DEPARTMENT OF THE ARMY
US ARMY CHEMICAL SCHOOL
401 ENGINEER LOOP
FORT LEONARD WOOD, MISSOURI 65473-8926

The additional information you requested in your letter dated March 1, 2000 concerning the groundwater assessment of the Pelham Range site is attached.

**RESPONSE TO REQUEST FOR ADDITIONAL INFORMATION CONCERNING
RADIOACTIVE MATERIALS LICENSE AMENDMENT REQUEST
DATED MARCH 2, 1999**

EULATON QUADRANGLE
ALABAMA-CALHOUN CO.
7.5 MINUTE SERIES (TOPOGRAPHIC)
NW 1/4 ANNISTON 15' QUADRANGLE

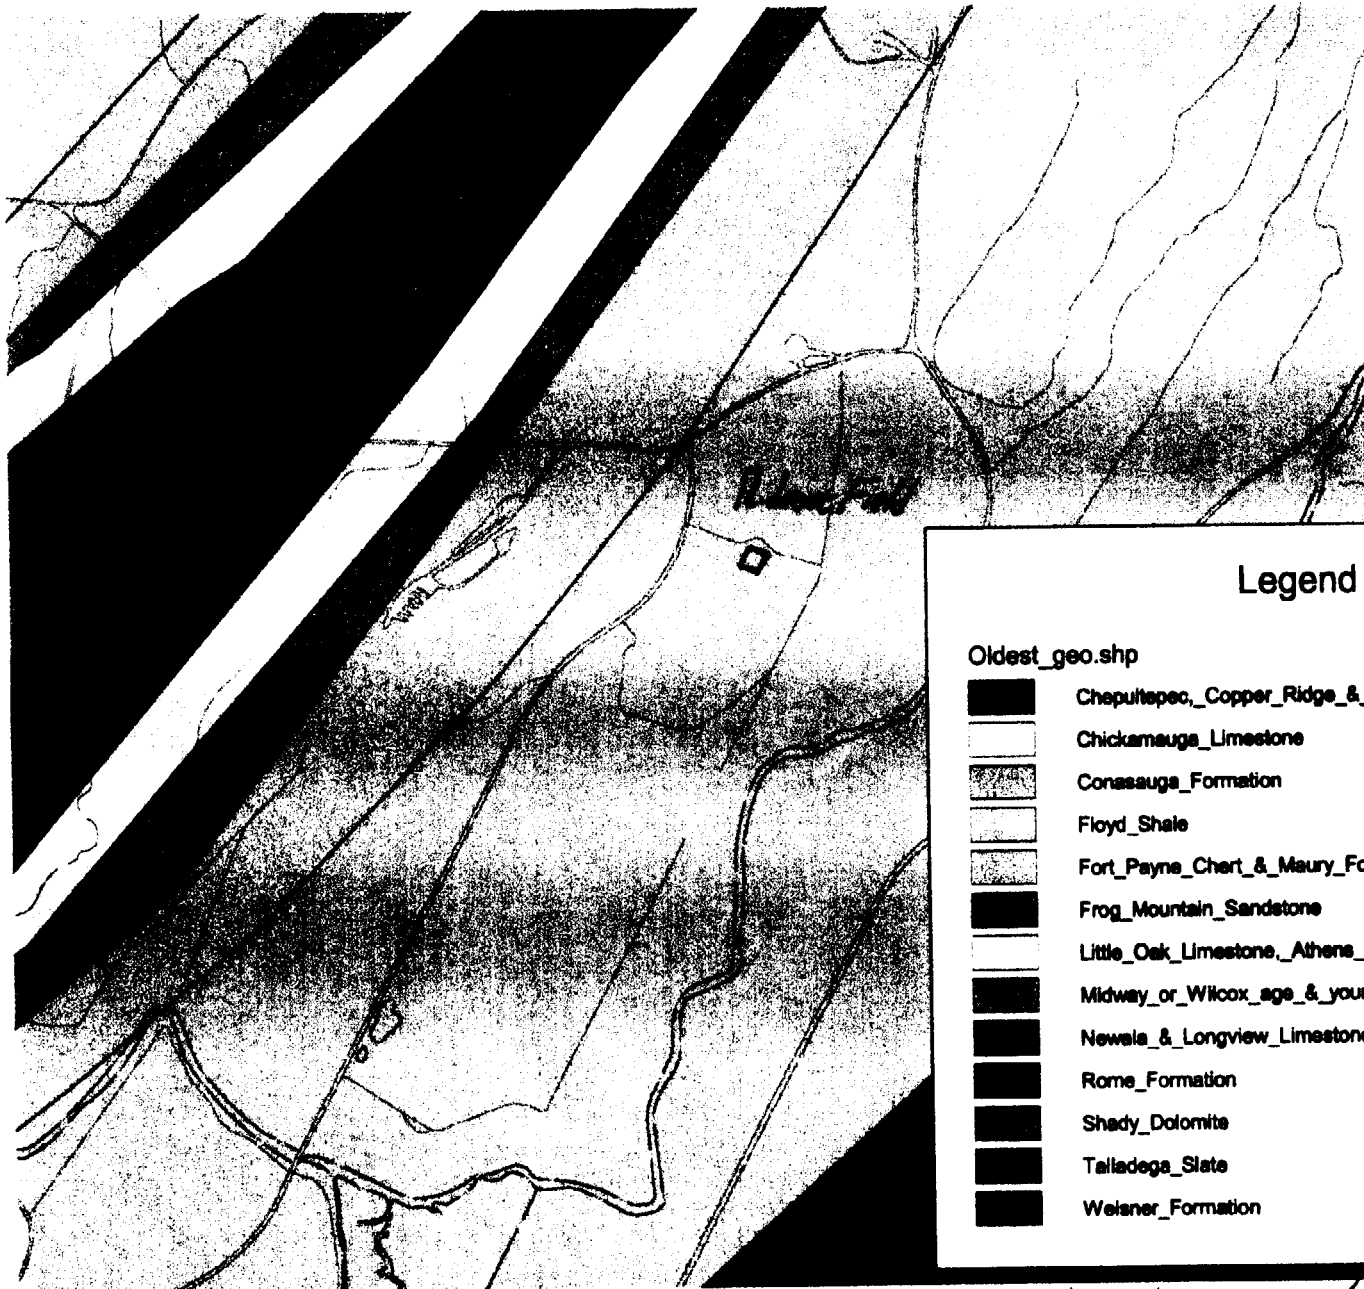
Comment 4: **Existing hydrogeologic data for this area should be compiled and examined. This would include a topographic map of the site, which can be used to delineate surface water drainage and to estimate water table elevations for perennial surface water features.**

Response: There is not any historic hydrogeologic information that has been collected for this area. During installation of planned monitoring wells, hydrogeologic data will be collected for this area. A topographic map is attached to show surface water drainage. Water table elevations and the direction of groundwater flow will be defined with the well installation program.
